Product Change Notice: PhotoMOS® Power DIP4/DIP8 and Phototriac Coupler: DIP4/DIP6 (Wide Terminal Type)

06.11.2026

Product Group #: 01

Example: Phototriac Coupler DIP6 ( Wide terminal type )

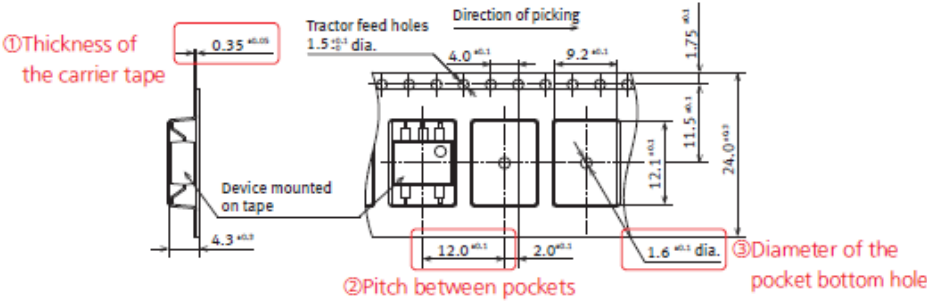
We would like to inform you that there will be changes made to our tape and reel carrier tape dimensions. Please see change details for specifics.

| Changes                             |                     |       |                     |       |                                                |       |                                                |       |
|-------------------------------------|---------------------|-------|---------------------|-------|------------------------------------------------|-------|------------------------------------------------|-------|
| ①Thickness of the carrier tape      | 0.3                 | 0.4   | 0.3                 | 0.4   | 0.35                                           | 0.4   | 0.35                                           | 0.4   |
| ②Pitch between pockets              | No changes          |       | No changes          |       | No changes                                     |       | 12                                             | 16    |
| ③Diameter of the pocket bottom hole | Φ1.50               | Φ2.00 | No changes          |       | Φ1.60                                          | Φ2.00 | Φ1.60                                          | Φ2.00 |
